M.N. Dyeing, Printing & Washing Mills Ltd

24 Sep & 09 Oct 2023

Observations

Provided concrete core test report (Typical)

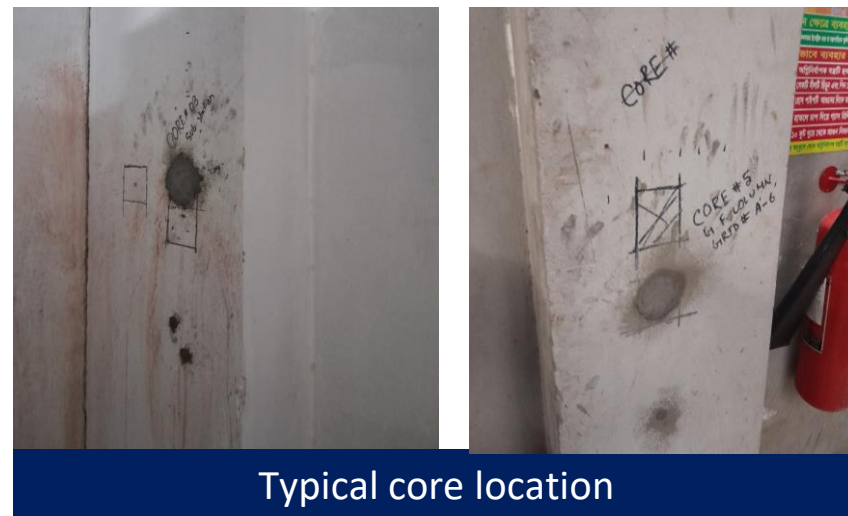
At the time of inspection several sets of concrete core test report were available for the structures. However, no core test layout plan was found at site. Building engineer is required to produce a core layout and mark all the locations of the

Structural steel strength considered 50 ksi and rebar strength considered 72.5 ksi in EA report

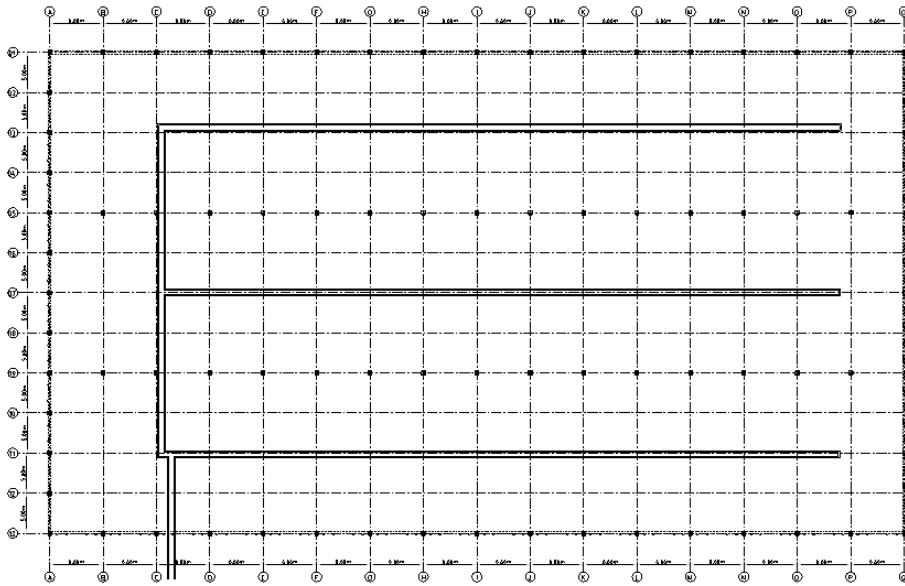
In EA report, the strength of structural steel was considered 50 ksi and rebar strength considered 72.5 ksi. But there was no test report available on-site. Building Engineer is required to prepare necessary test reports and revise EA documents accordingly.

Foundation Adequacy not shown in drawing (mezzanine portion)

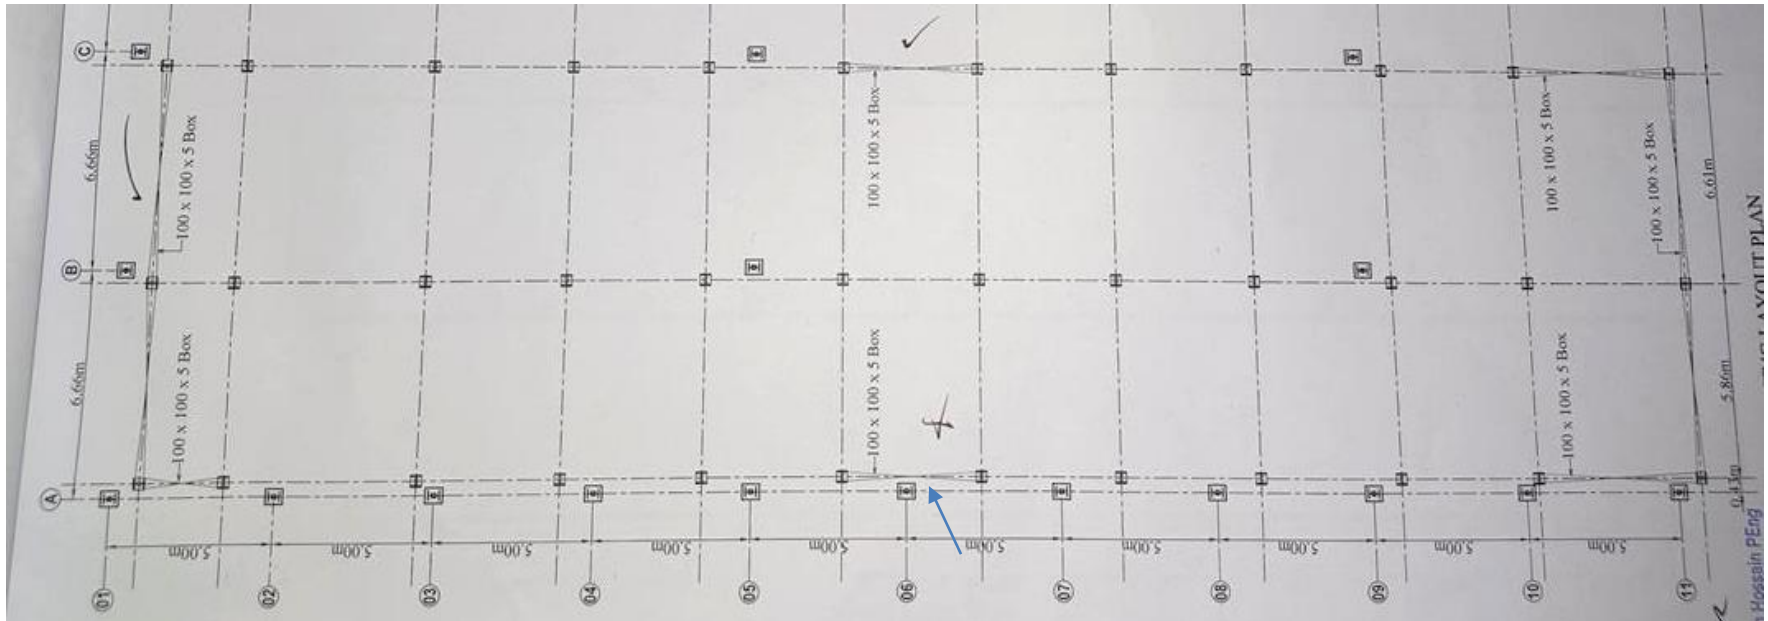
Foundation adequacy and details was not shown in as-built drawing of mezzanine floor. Building Engineer is required to revise the as-built drawing and other documents as per actual site condition.

Lack of anchorage of storage rack

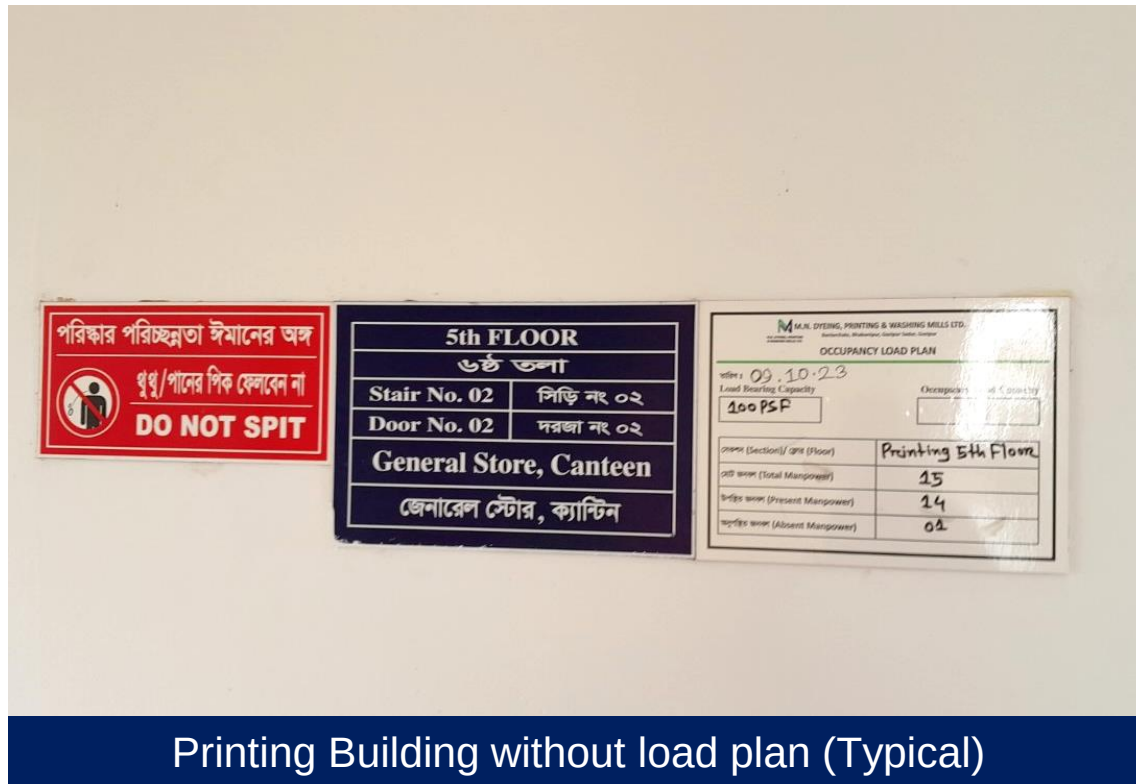
During inspection, lack of anchorage of storage racks was found. Building engineer is required to brace/anchor all the non-structural elements.

Figure 1: 3-D VIEW OF 7-STORIED PRINTING BUILDING FOR "MN PRINTING AND WASHING MILLS LIMITED"

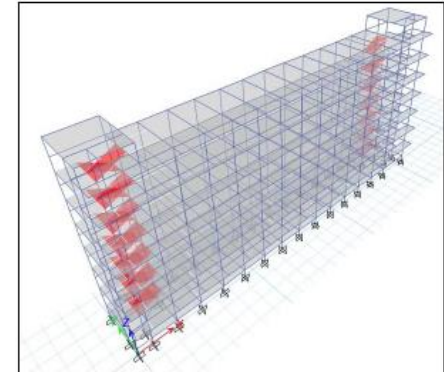
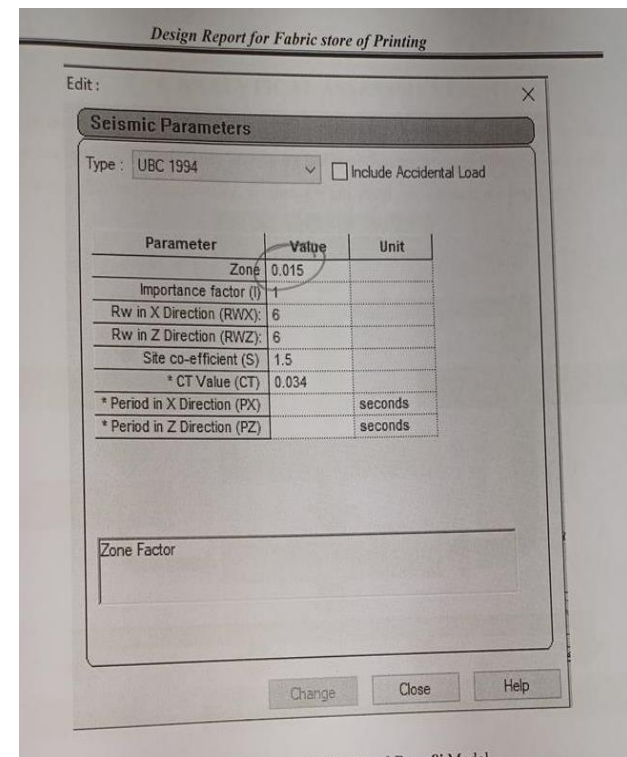
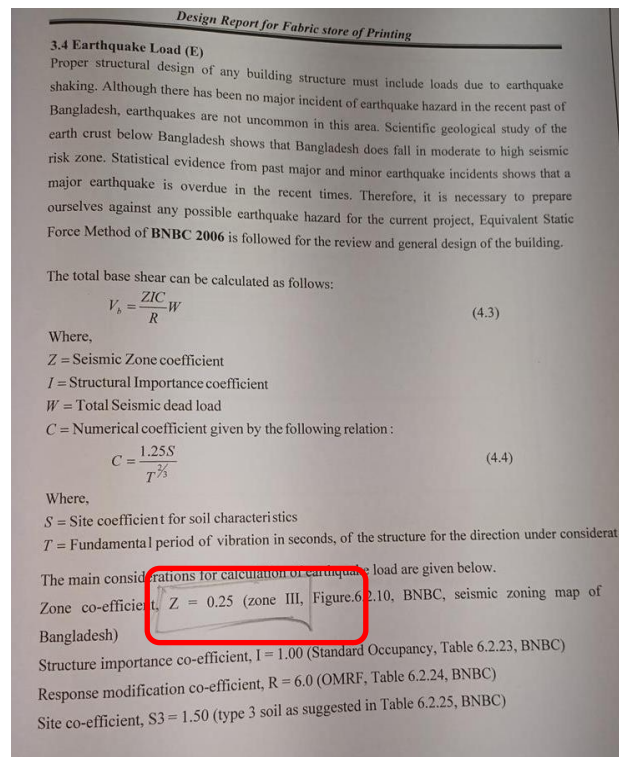
The building is apparently slender (length to width ratio > 7). The building engineer is required to check the lateral stability of the structure as per BNBC in details and suggest proper remedial actions if required.

Mis-match in location and zone (Z)

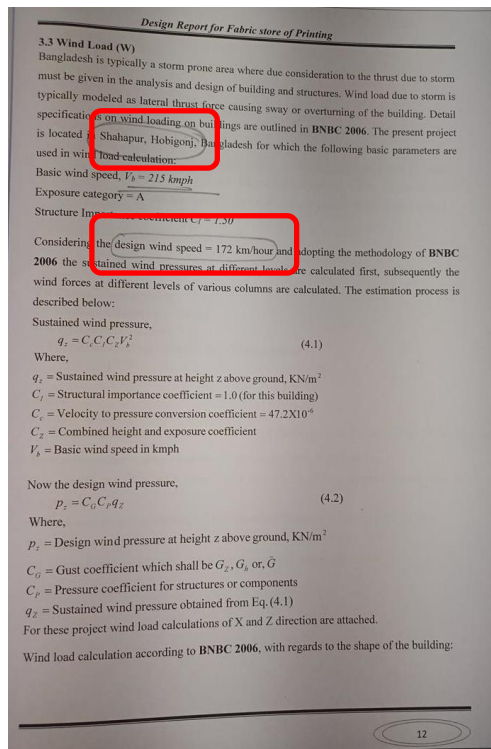
Inconsistencies in design report was observed. Building engineer is required to revised the design report as per actual condition and submit to RSC for review.

Lack of connection adequacy and lateral stability System

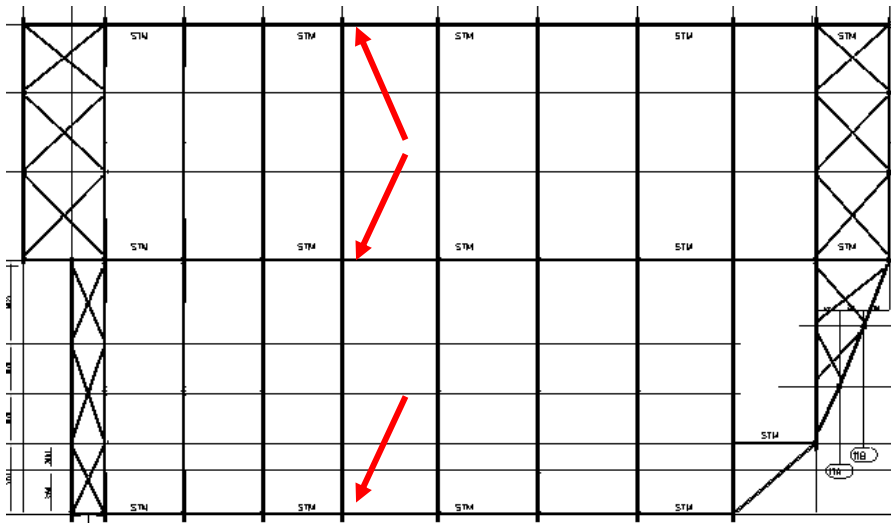
Apparently inadequate member size and connections were observed in the lightweight roof. Building engineer is required to check the connection adequacy and lateral stability system of the structure.

Strut in drawing

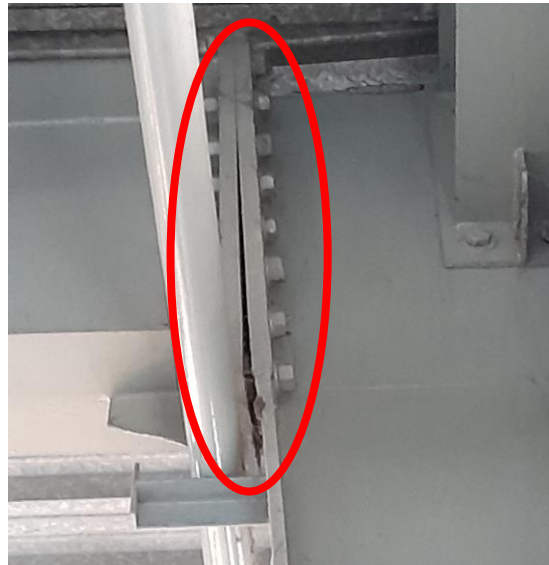
No vertical bracing and compression member was observed in the structure that indicates the lateral load path is not logical in long direction against lateral loading. Also strut members are shown in drawing, but no strut members are found during inspection. Building engineer is required to revise the drawing, design report, check the connection adequacy and lateral stability of
